In the Drawings:

YOR9-2000-0402 US1 (RPT) (8728-497)

— Prior Art —

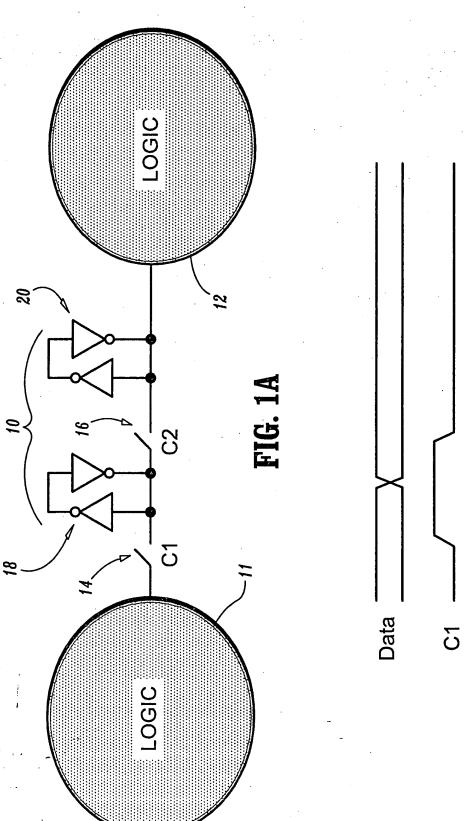
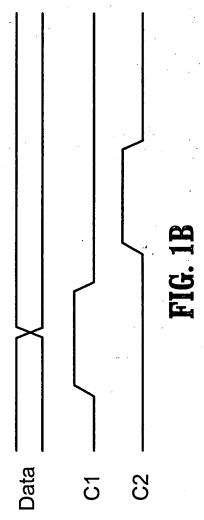
Figures 1A, 1B, 2A, and 2B have been amended to include the legend "- -Prior Art- -" as represented in the Replacement Sheets for Figures 1A, 1B, 2A, and 2B, attached to end of this document.

6/12 YOR9-2000-0402 US1 (8728-497)

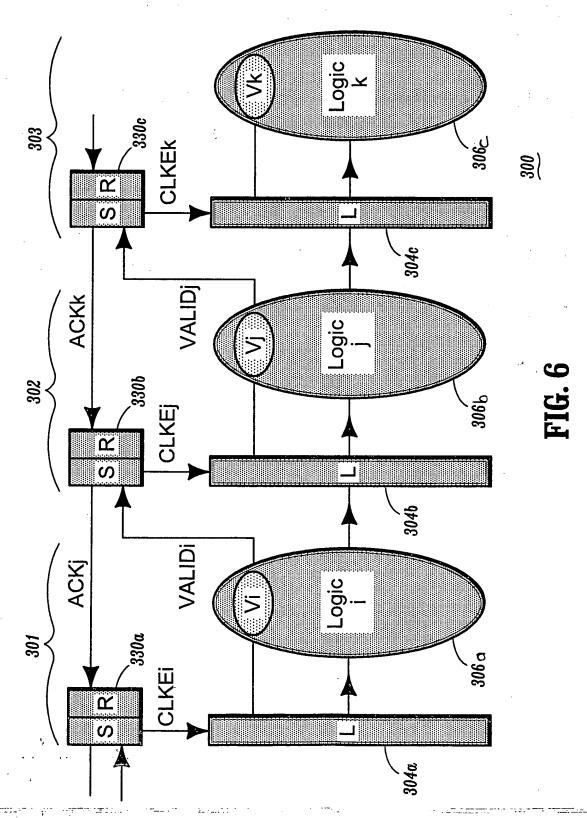
In the original Figure 6 the reference character "306" had been used to designate "Logic i", "Logic j", and "Logic k". As represented in the Replacement Sheet for Figure 6, attached to the end of this document, reference character "306a" is now used to designate "Logic i". The reference character "306b" is now used to designate "Logic j". The reference character "306c" is now used to designate "Logic k".

9/12 YOR9-2000-0402 US1 (8728-497)

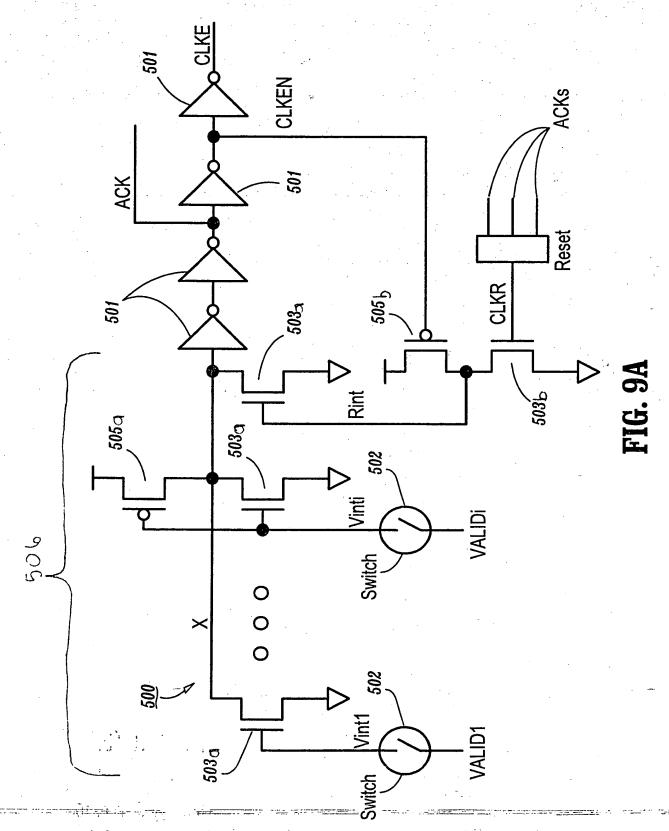
In the original Figure 9A the reference character "506" described in the specification did not exist. As represented in the Replacement Sheet for Figure 9A, attached to end of this document, the reference character "506" along with a brace has been add to the figure to identify the static NOR. The n-channel devices, originally labeled "503", have been relabeled. The n-channel devices that comprise the static NOR 506 have been relabeled to "503a". The remainder of the n-channel devices has been relabeled to "503b". The p-channel devices, originally labeled "505", have been relabeled. The p-channel devices that comprise the static NOR 506 have been relabeled to "505a". The remainder of the p-channel devices has been relabeled to "505b".

In the original Figure 9B the reference characters "503" and "505" were used to label all the n-channel devices and p-channel devices respectively. As represented in the Replacement Sheet for Figure 9B, attached to the end of this document, the n-channel devices and p-channel devices have been relabeled. The n-channel device that comprises the static NOR

506 has been relabeled to "503a". The remainder of the n-channel devices has been relabeled to "503b". All the p-channel devices have been relabeled to "505b".
